**Norfolk Boreas Offshore Wind Farm**

# **Statement of Common Ground**

**Norfolk County Council**

Applicant: Norfolk Boreas Limited  
Document reference: ExA.SoCG-19.D16.V4  
Deadline 16

Figure 1. Location of Access A, B and D1 on the A47 at Necton

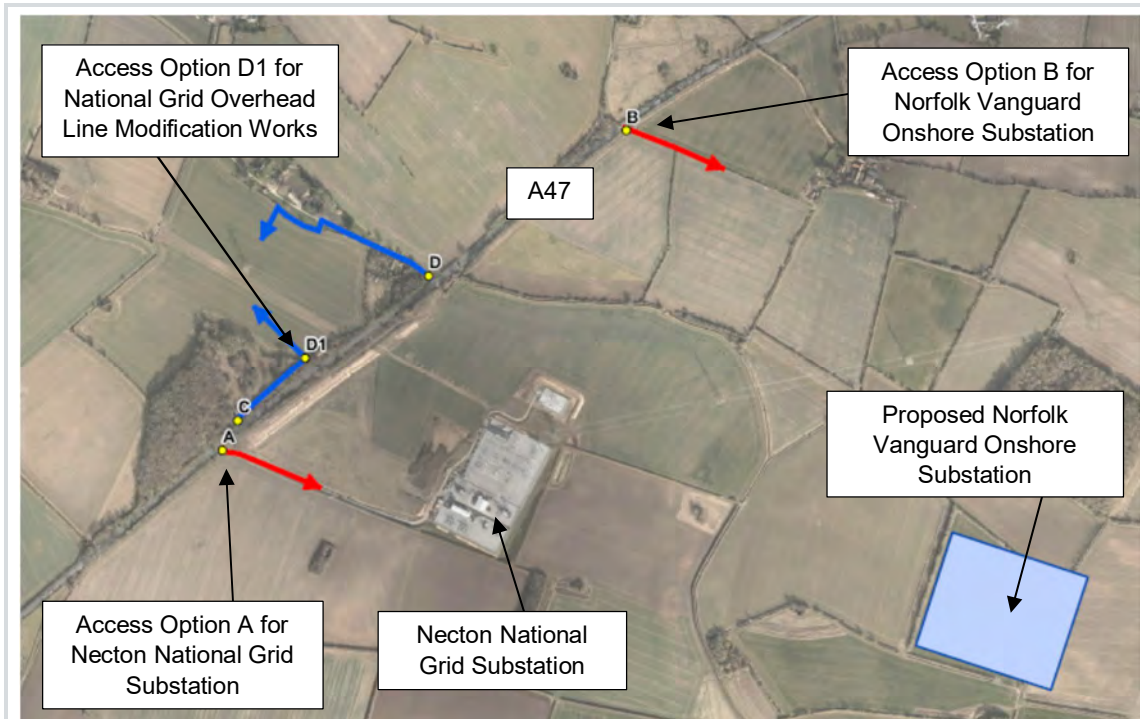
11. The SACTN contains a statement that *'Increasing the 'x' distance to 4.5m would require the removal of a large proportion of established hedgerows, vegetation and trees. This will have ecological impact and would remove much of the native mature screening required to mitigate the landscape impact'*. In the circumstances, this appears to be sufficient grounds to permit what is effectively a two-step permitted relaxation in the provision of emerging visibility at access point B.

13. On that basis, the layouts currently offered for access points A, B and D1 appear satisfactory, subject to:
- visibility splays being cleared of foliage;
  - visibility being proven in the vertical plane;
  - the implementation of the traffic management measures proposed; and
  - the carrying out of Stage 1 and 2 Road Safety Audits.

15. The updated layouts, traffic management arrangements and traffic flows presented in the SACTN provide sufficient confidence to allow AECOM to advise Highways England that they could now form the basis of an updated Statement of Common Ground indicating Highways England's agreement in principle with the access arrangements proposed.

Figure 1. Location of Cable Crossing sites and proposed access routes

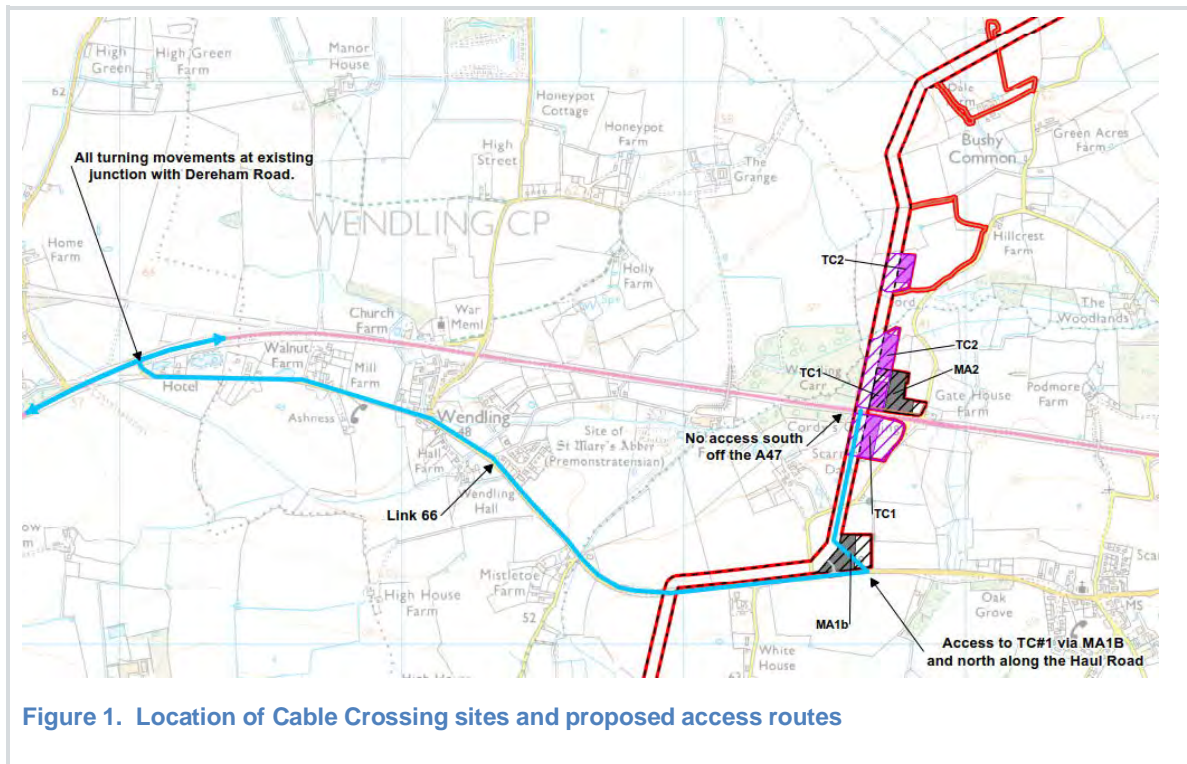
15. The layout of site access junction AC160 illustrated on Drawing PB4476-DR025 D0.1 appears to provide satisfactory geometry to accommodate heavy vehicles turning to and from the A47. There is no suggestion that the use of this junction by vehicles accessing the works would give rise to a queue of stationary traffic within Bushy Common Road waiting to enter the site, such as would risk generating a queue of traffic back to the A47, some 50m away.

17. The visibility splay to the right illustrated for the site access junction appears to provide visibility from an x-distance of 2.4m back into the minor arm all the way to the A47, some 50m away. Whilst this does not strictly comply with the requirements of TD41 Table 2/1, a visibility splay as far as the preceding junction should in practice be adequate to allow the driver of a vehicle emerging from the site access to see a vehicle approaching from the A47 at up to 30 mph. Speeds around the 15m corner radii between the A47 and Bushy Common Road are likely to be less than this. The relaxation of the X distance from 4.5m to 2.4m would be permitted in this location (TD41 para 2.21 refers).

19. The layout of the improved junction between the A47 and Bushy Common Road, illustrated on Drawing PB4476-DR025 D0.1, appears to provide in full for the requirements of DMRB Design Standard TD42 for this type of junction. In addition, the swept path plots shown on Drawings PB4476-DR026 and 027 show that it can accommodate heavy vehicles turning on and off the A47 without clipping kerb lines, and without encroaching on the wrong side of the A47 or the minor road.

21. Whilst the visibility splays have not been proved in the vertical plane, the local topography is generally flat, although there appears to be a slight rise towards the back of the verge on the north side of the A47 to the west of the junction and this should be addressed as the design of the junction progresses. AECOM note that the land behind the highway verge lies within the red line boundary of the development and it is therefore within the power of the Applicant to address any problems.

25. There is no evidence that a Stage 1 Road Safety Audit has been undertaken in respect of these layouts. The CCATN contains an undertaking to carry out both a Stage 1 and a Stage 2 Road Safety Audit and to prepare detailed Traffic and Access Management Plans post consent.
26. On that basis, the layouts currently offered for access to the Cable Crossing work sites at Scarning appear satisfactory, subject to:
- visibility splays being cleared of foliage;
  - visibility being proven in the vertical plane;
  - the implementation of the traffic management measures proposed, including the monitoring of banned right turns; and
  - the carrying out of Stage 1 and 2 Road Safety Audits.

30. The updated layouts, traffic management arrangements and traffic flows presented in the CCATN provide sufficient confidence to allow AECOM to advise Highways England that they could now form the basis of an updated Statement of Common Ground indicating Highways England's agreement in principle to the access arrangements proposed.

Plate 1: Proposed works area

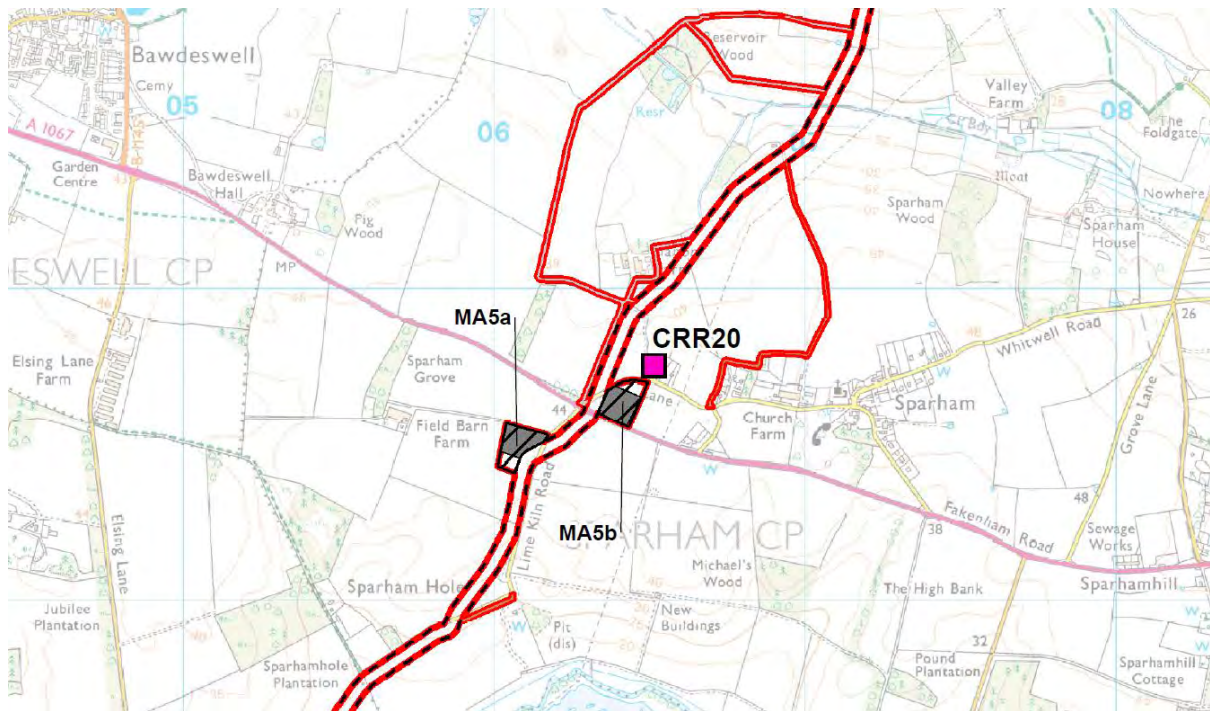
<p><b>A1067 crossing</b></p> <p>An investigation has been undertaken in response to the concerns raised by NCC on the potential impacts of open cut trenching on the A1067 and was submitted as part of the Norfolk Vanguard examination at Deadline 7.5 (see Appendix 2).</p> <p>Updated traffic counts were undertaken on the A1067 in April 2019. These show increased usage of the A1067 as a result of the operation of the Norwich Northern Distributor Road and forecast traffic flows for Norfolk Vanguard would now exceed the total vehicles per hour level at which single lane traffic management may be undertaken without network disruption. As a result, under Norfolk Boreas Scenario 2 the Applicant has now committed to undertake the crossing of the A1067 using trenchless techniques. This trenchless crossing will be included on the list of trenchless crossings in DCO Requirement 16 the</p>	<p>The commitment to trenchless crossing of the A1067 is welcomed.</p>	<p>Agreed</p>

Enhanced mitigation in the form of standard 3.5m high noise absorptive barriers were introduced and the noise levels re-modelled. With enhanced mitigation, the modelled noise level at the nearest noise sensitive receptor reduced to 39.3dBA, representing a residual noise impact of **negligible** significance. A Construction Noise Management Plan (CNMP) will be included in the final Code of Construction Practice (CoCP) as required under Requirement 20 (2)(e) of the DCO. Enhanced mitigation at the closest noise sensitive receptor to the A1067 crossing will be captured within an update to the Outline CoCP.
